BP 10441-B  
Permit No.

# Minor Change Request

for revisions to previously issued permits

**Lake View Plantation, Piscataquis County, Maine**

FILE: CC-328  
SQ.FT.: 988  
STATE: ME  
TYPE: RANCH  
MODEL: SETTLER  
DRAWING: FOUNDATION  
SHEET: 1

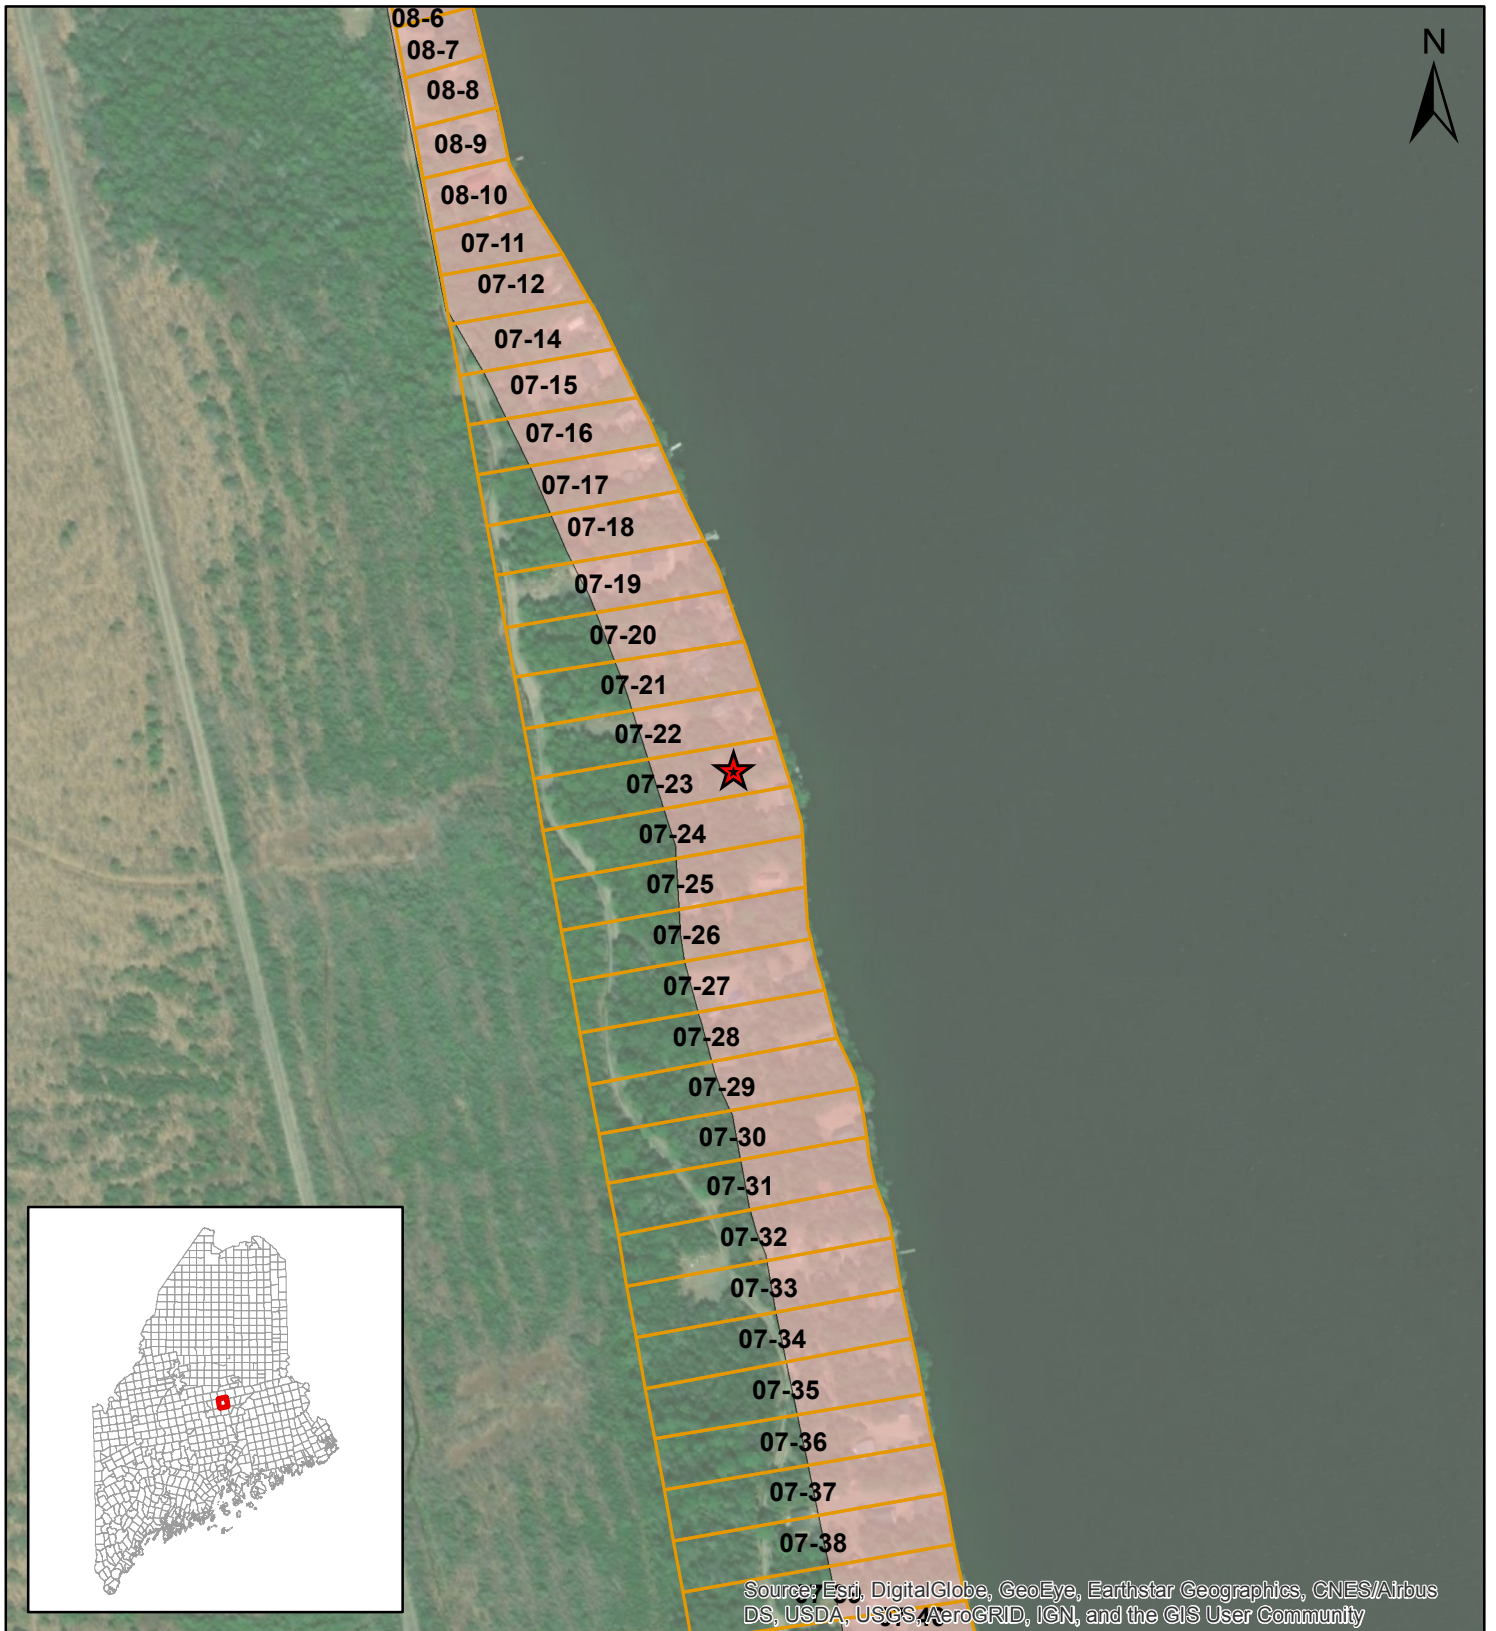
Clarifying permitted size of the dwelling unit and attached covered porch approved under BP 10441-A.  
The permitted size of the dwelling is 26 feet by 38 feet and the permitted size of the porch is 6 feet by 26 feet.  
See attached Engineer Plan CC-328, dated 3/24/2015 and submitted by the Applicant on July 16, 2018.
